**ADDENDUM #2
Public Works – Building Services
HMMF Expansion
BID # 7203-21**

February 26, 2021

The attached addendum supersedes the original Information and Specifications regarding BID # 7203-21 where it adds to, deletes from, clarifies or otherwise modifies. All other conditions and any previous addendums shall remain unchanged.

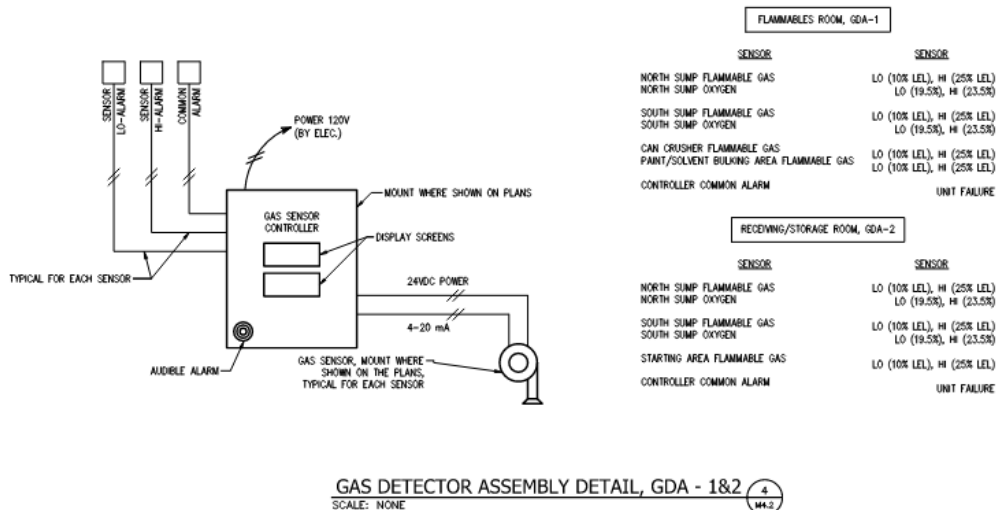
58. Question: Ref M2.1 MUA Auto Fill & Drain. How is this going to work with the MUA on a slab on the ground? Where does the 1/2" water come from?

ANSWER: The existing drawing indicates an existing CW line feeding AHU-2. The drawings show connecting to this and extending over to the new MUA. The detail shown is for a roof mounted unit. The fill and drain valve would be located inside the building similar to the existing unit.

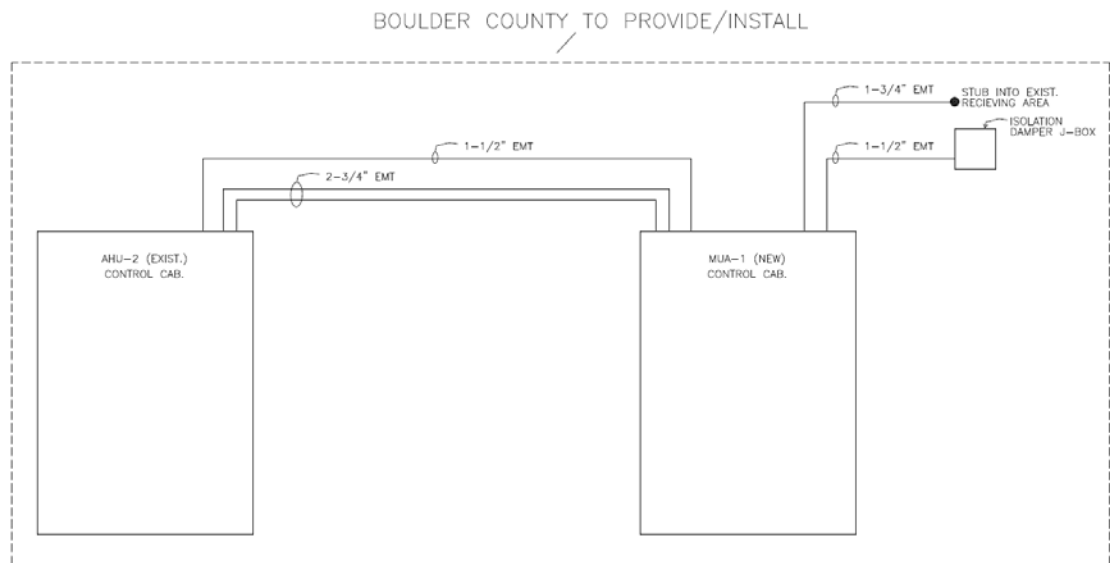
80. Question: HVAC Plans call for multiple potential HVAC Controls systems (Honeywell, Johnson Controls, or equipment manufacturer). It was briefly mentioned on the walk that Boulder County sometimes prefers Andover? Is there a required HVAC controls system for this project?

ANSWER: Boulder County will provide/install HVAC controls associated. Per M4.1, 1.12 Coordination, use the following for coordinating the controls work with Boulder County (BC) representative.

B. Electrical work performed by this contractor will conform to the standards of Division 26-28. Mechanical equipment motors and controls shall be furnished, set in place, and wired according with the following schedule unless otherwise noted or specified. MC = Division 21-23 EC = Division 26-28

Item	Furn By	Set By	Power Wiring	Control Wiring
Combination starters	BC	EC	EC	BC
Equipment motors	MC	MC	EC	--
Motor starters & O.L. relays	EC	EC	EC	BC
Disconnect switches	EC	EC	EC	--
Thermal overload heaters (1)	EC	EC	EC	--
Variable Speed Drives	BC	EC	EC	BC
Control relays/transformers	BC	BC	EC	BC
Temperature control panels	BC	BC	EC	BC
Temp. Controls conduit/wiring	BC	BC	--	BC
Actuator and solenoid wiring	BC	BC	--	BC
Pushbuttons & pilot lights	MC	MC	--	MC
Room thermostats	MC	MC	--	MC
Thermostats: line voltage	EC	EC	EC	--
